PERFORMANCE SPECIFICATION SHEET

SEMICONDUCTOR DEVICE, DIODE, SILICON,
SCHOTTKY BARRIER, FAST RECOVERY,
TYPE 1N6391, JAN, JANTX, JANTXV, JANS, AND JANHC

This amendment forms a part of MIL-PRF-19500/553A, dated 27 June 1997 and is approved for use by all Departments and Agencies of the Department of Defense.

Figure 1. Physical dimensions (similar to DO-41).

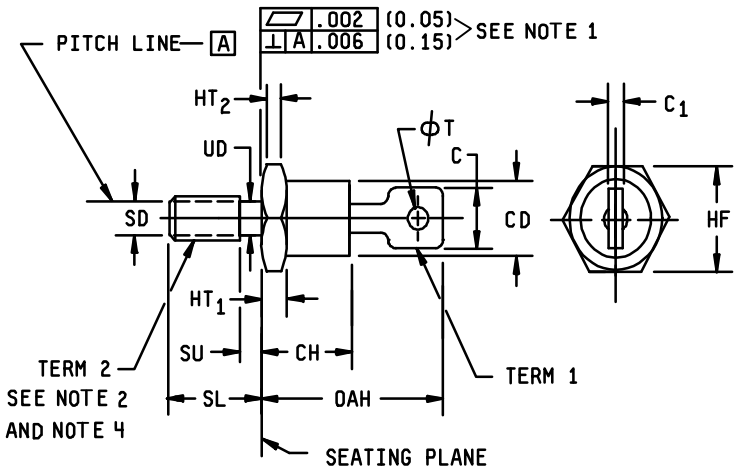
Figure 1 Physical dimensions. Delete in its entirety and substitute:

Ltr	Dimensions				Notes
	Inches		Millimeters		
	Min	Max	Min	Max	
C		.250		6.35	6
C_1	.018	.065	0.46	1.65	
CD	.265	.424	6.74	10.76	
HF	.403	.437	10.24	11.10	
HT_1	.075	.175	1.91	4.44	
HT_2	.060		1.53		5
CH	.300	.405	7.62	10.28	
OAH	.600	.800	15.42	20.32	
UD	.163	.189	4.14	4.80	
SD					4
SL	.422	.453	10.72	11.50	
SU		.078		1.98	3
ϕT	.060	.103	1.52	2.62
